PLANNING CONSULTANCY

Re: Planning & Development Act 2000 and the Statutory Regulations made thereunder (as amended). Submission by Ballyboden Tidy Towns CLG, 17 Glendoher Close, Rathfarnham, Dublin, D16 N2Y0 in relation to a Strategic Housing Development application for a development comprising the demolition of Kilmashogue House and Coill Avon House, the construction of 178 no. residential units (houses, apartments and duplexes), a neighbourhood centre, creche and all associated ancillary development works at a site at Kilmashogue House and Coill Avon House, Whitechurch Road, Rathfarnham, Dublin 16

An Bord Pleanála Ref. TA06S.313059

Taylor's Lane / Whitechurch Road

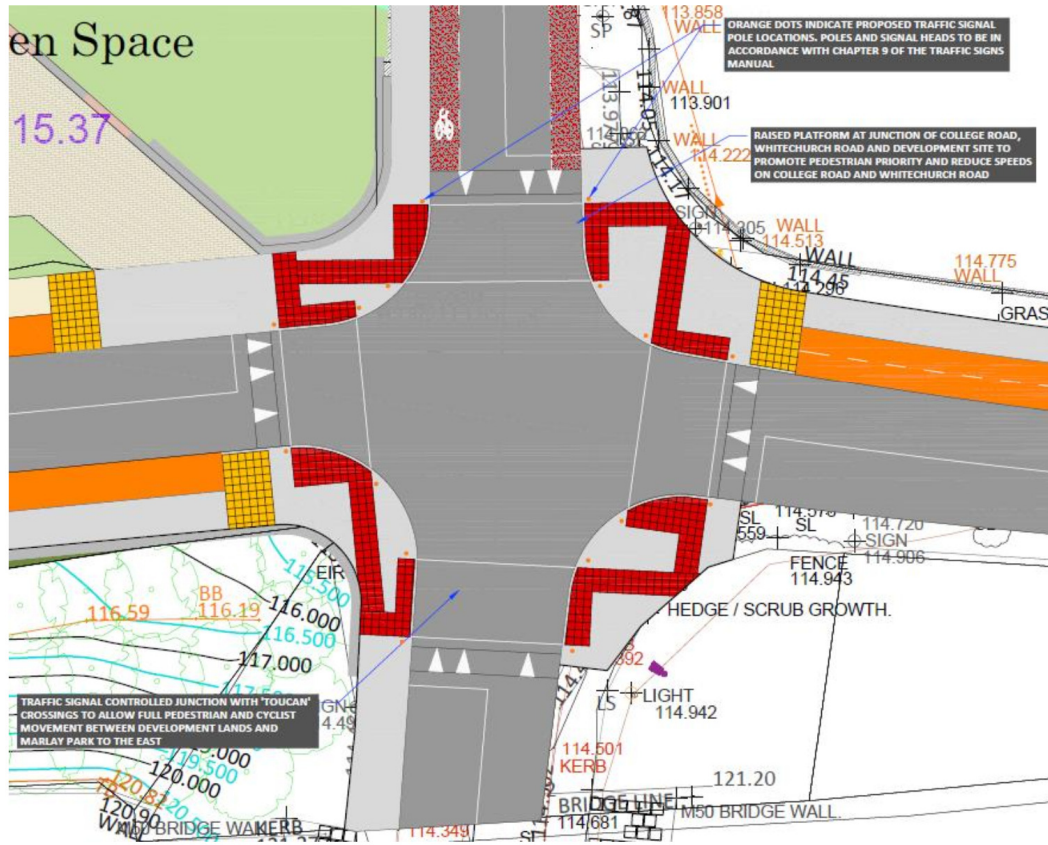
- 5.4.3 A 2.1% increase in traffic flows would not normally require a detailed assessment of junction capacity. However, the junction is already heavily trafficked and even a modest increase in traffic flows could make a material difference to its operation and the associated queuing and delays that arise. It is considered that a detailed assessment of the junction should have been undertaken within the TAR and that the necessary revision of the growth factors, trip rates, trip distribution and committed development now makes it essential.

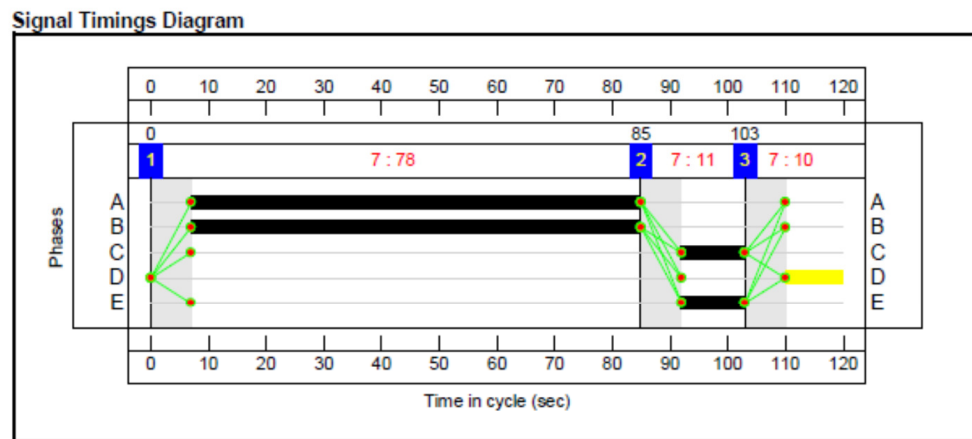
- 5.4.7 It is proposed to convert the existing three arm yield junction into a four arm signalised junction as identified in the junction layout plan below. The north and south arms are Whitechurch Road, the east arm is College Road, and the west arm is the initial section of the proposed link road that also acts as the site access to the southern element of the proposed development.

- 5.4.8 The operation of the proposed junction has been assessed through use of the LINSIG computer software with the results being summarised in Table 4.5 of the TAR. The maximum Degree of Saturation (DoS) for the signals is identified as being 34% which is well below the 90% value which is taken as representing effective operational capacity.

- 5.4.9 Although the proposed junction is shown to operate within capacity in the short term, it must again be noted that the traffic flows used for the assessments are not accurate as they do not allow for full delivery of the wider zoned lands accessed via the western arm, nor do they allow for the potential redistribution of through traffic associated with completion of the full link road. It is essential to fully assess the operation of the junction with the zoned lands and the proposed link road in place otherwise it cannot be known whether it will be constructed with sufficient capacity to cater for this longer term scenario.
